COUNCIL ACTION FORM

REQUEST: MAJOR SITE PLAN AMENDMENT FOR 3619 STANGE ROAD, PART OF AN INTEGRATED SITE PLAN FOR THE NINETEENTH ADDITION TO NORTHRIDGE HEIGHTS SUBDIVISION.

Major Site Development Plan

3619 Stange Road

Proposed Major Site Plan

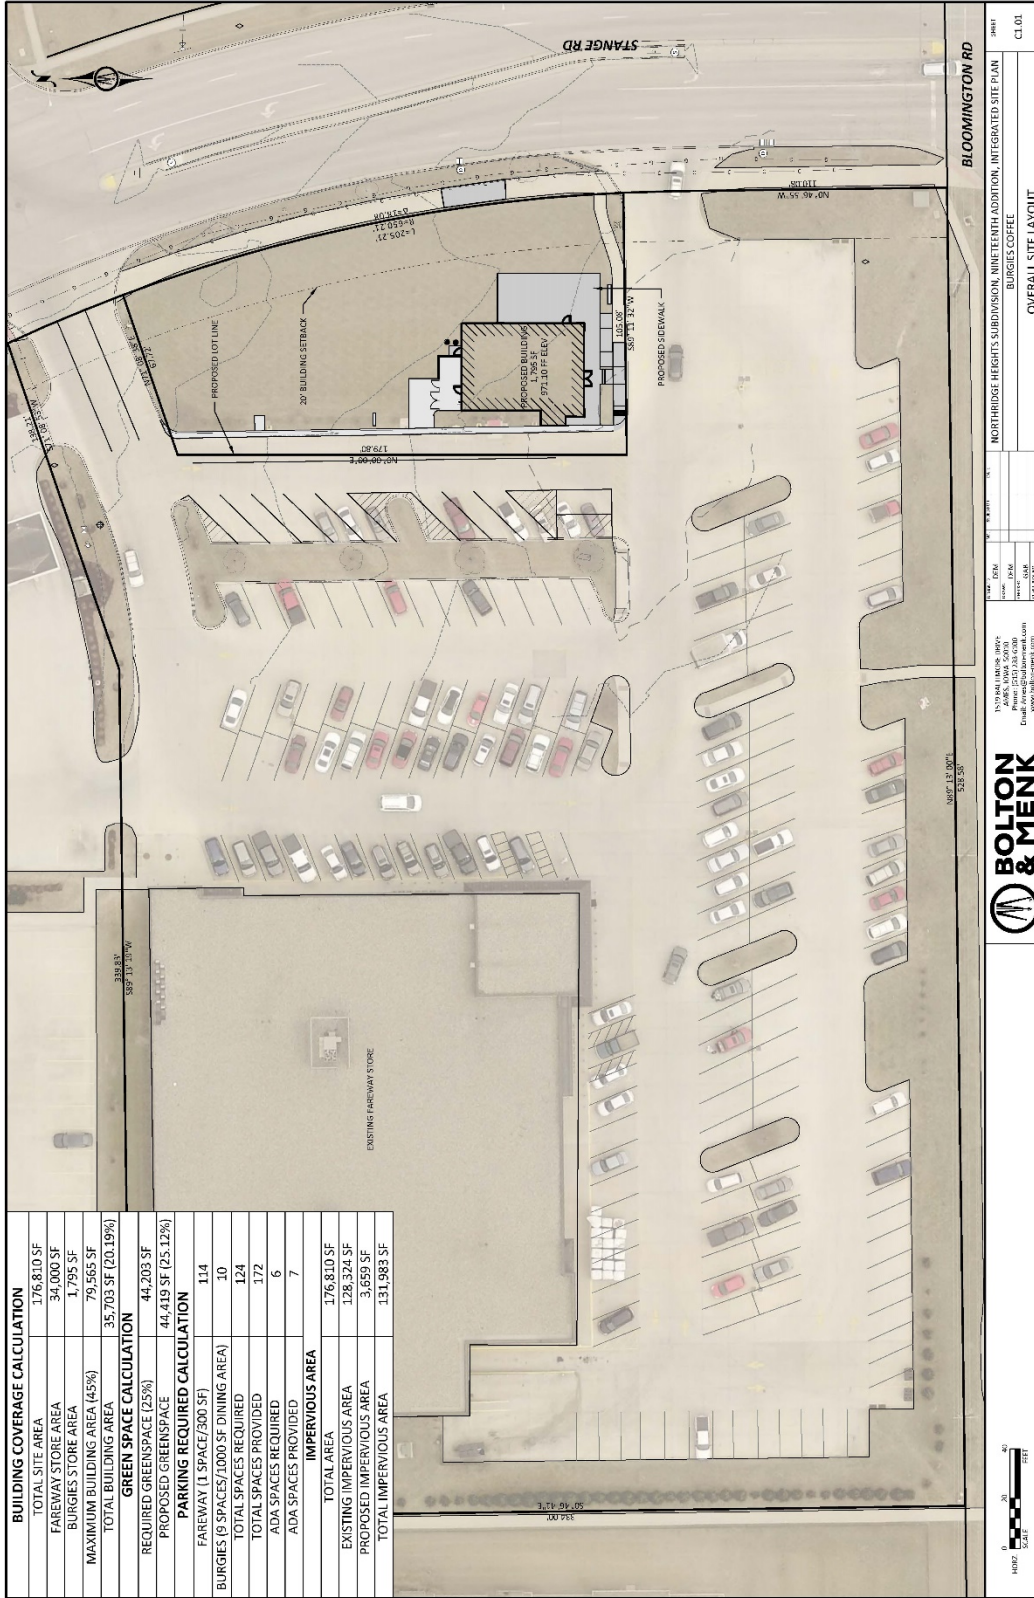
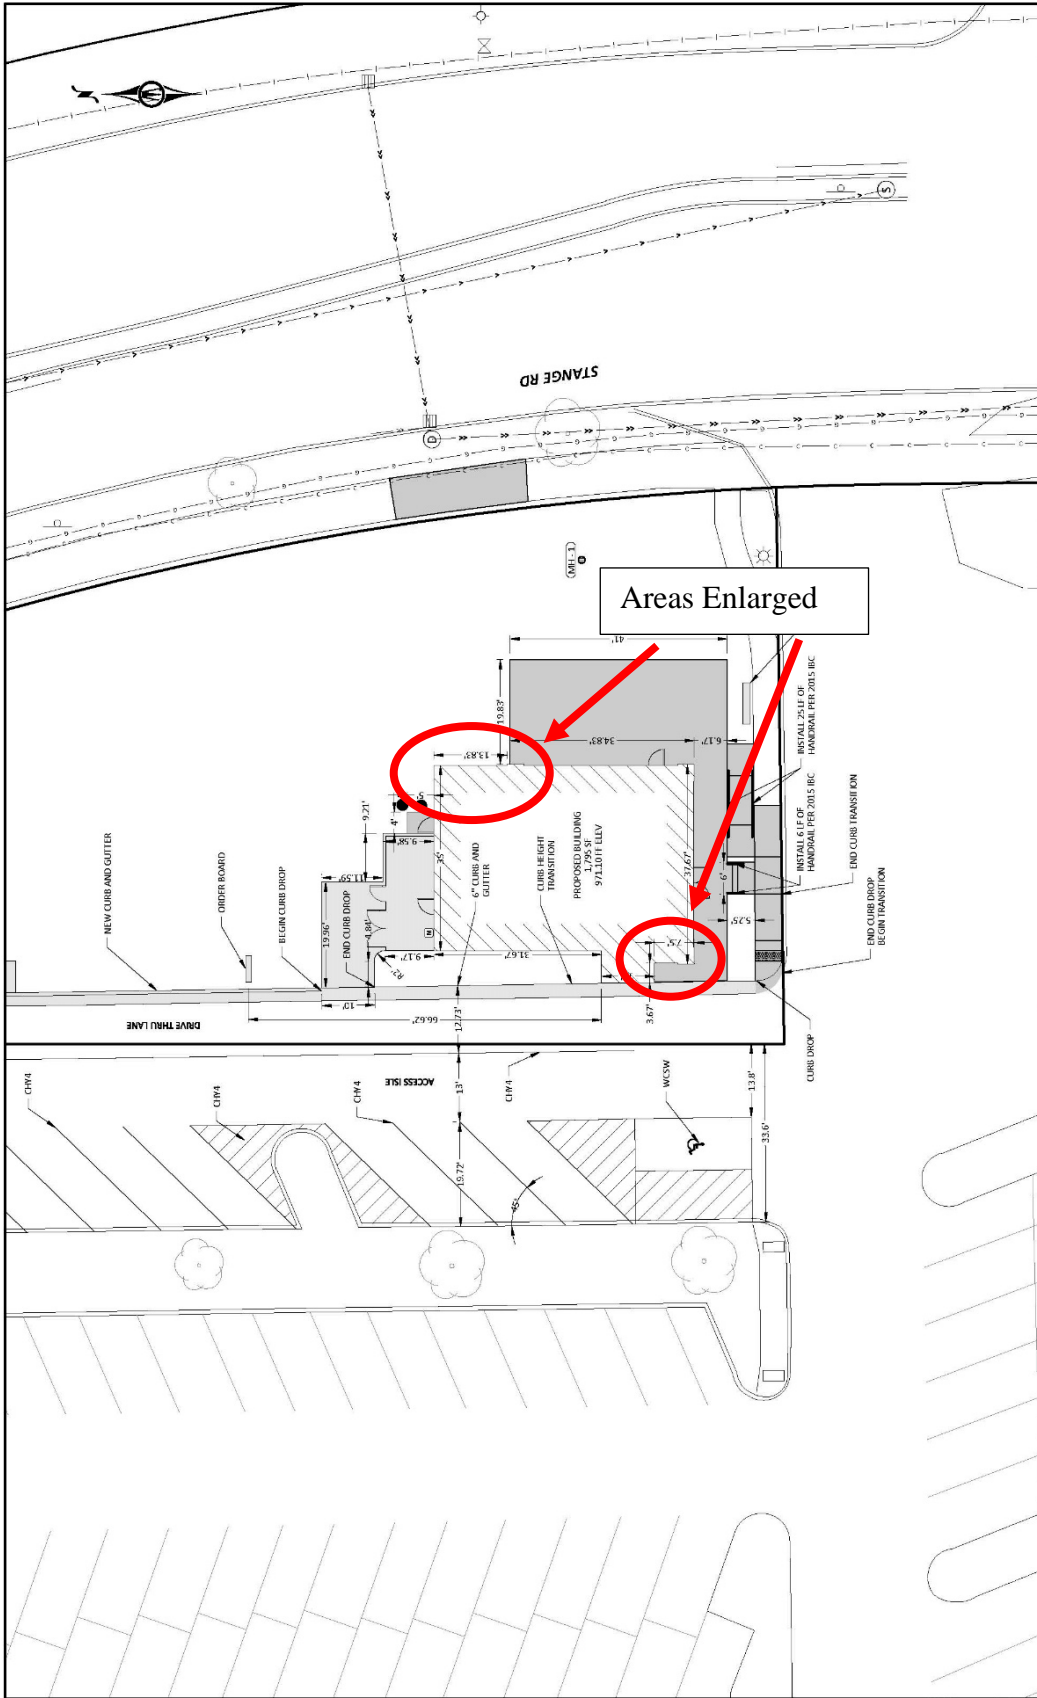
- i. Correct the following:
 1. The label for the required bike rack, currently denoted as a sign.
 2. The Total Building Area and Building Coverage on C1.01.
 3. The parking calculation, which should be 12 spaces / 1000 square feet of dining area (the total required spaces comes to the same number) on C1.01.
- ii. Compliance with the City's Outdoor Lighting Code as approved by staff.

1. Approve the Major Site Development Plan, subject to the following stipulations:
 - i. Correct the following:
 1. The label for the required bike rack, currently denoted as a sign.
 2. The Total Building Area and Building Coverage on C1.01.
 3. The parking calculation, which should be 12 spaces / 1000 square feet of dining area (the total required spaces comes to the same number) on C1.01.

Proposed Floorplan & Building Elevations

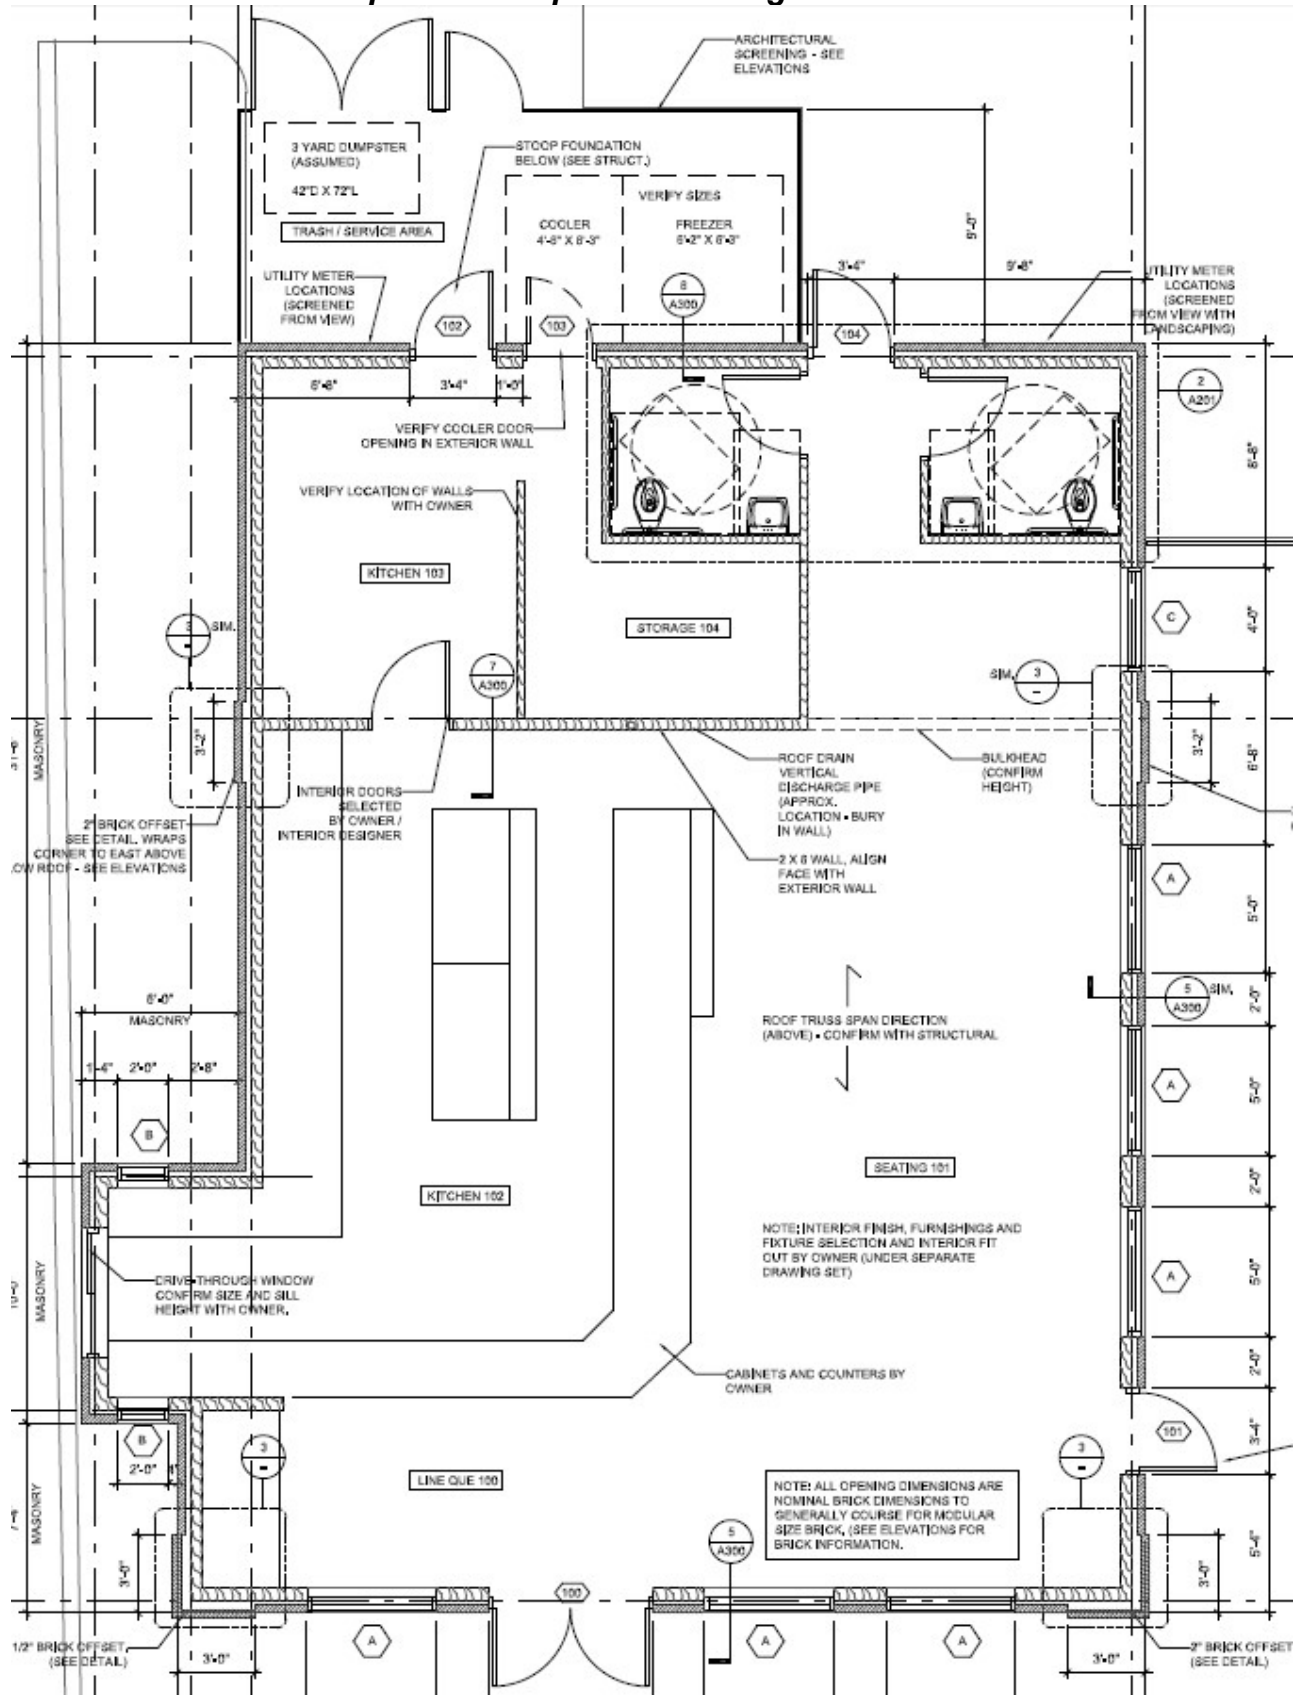
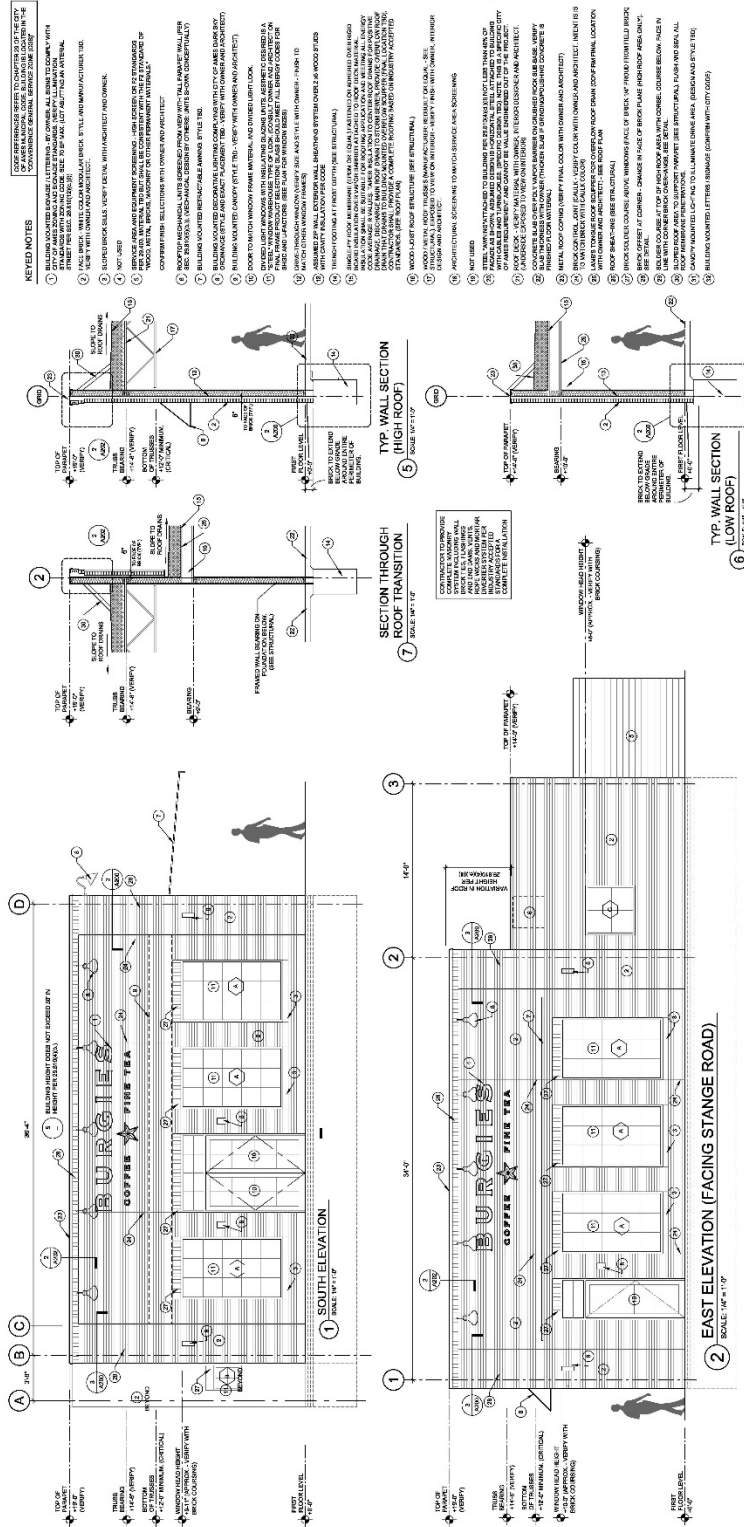
The west façade facing the parking lot does not comply with the requirements in Sec. 29.810(4)(d)(ii). This regulation requires that the façade be “subdivided and proportioned by openings, such as windows or doors, and/or projecting structures, such as arcades, arbors, or awnings, along no less than forty (40) percent of the length of the façade.” The applicant has agreed to add an arcade, arbor, or awning to comply with this requirement.

The building elevations do indicate lighting will be located on the buildings. Fixture information was not provided. It should be noted that all lighting on buildings and in parking areas will need to comply with the City’s Outdoor Lighting Code.
